APPLICATION NO.	FILING DATE	FIRST NAMED INVENTOR	ATTORNEY DOCKET NO.	CONFIRMATION NO.
10/630,457	07/29/2003	Kayoko Shibata	P/126-222	9037
2352	7590	11/04/2004	EXAMINER	
OSTROLENK FABER GERB & SOFFEN 1180 AVENUE OF THE AMERICAS NEW YORK, NY 100368403			NGUYEN, DANG T	
			ART UNIT	PAPER NUMBER
			2824

Office Action Summary	Application No.	Applicant(s)	
	10/630,457	SHIBATA ET AL.	
	Examiner	Art Unit	
	Dang T Nguyen	2824

DETAILED ACTION

Fig. 17 of Funaba teaches both the buses and the terminal resistors are part of the memory modules.

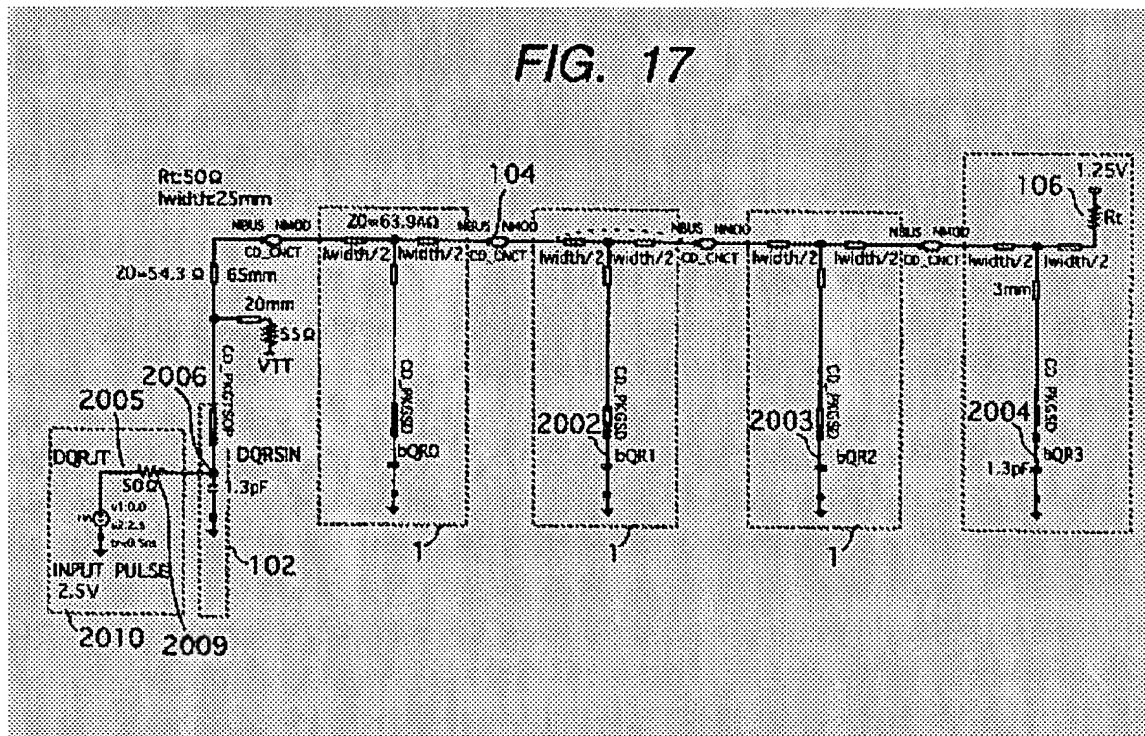
Regarding dependent claim 7, Fig. 17 of Funaba et al. discloses wherein said terminating resistor (106) is formed in said memory chip.

Examiner agrees with the Applicant that the reference of Funaba (Fig. 11) shows both the bus and the terminal resistors are on the motherboard, and not part of the memory modules. However, the structural limitation as recited in the independent claims 1 and 8 do not implicitly disclose or teach that the bus and the terminal resistors as a part of the memory module. Note that the 102 rejection is applied to the claim not the specification. Therefore, the argument is not persuasive.
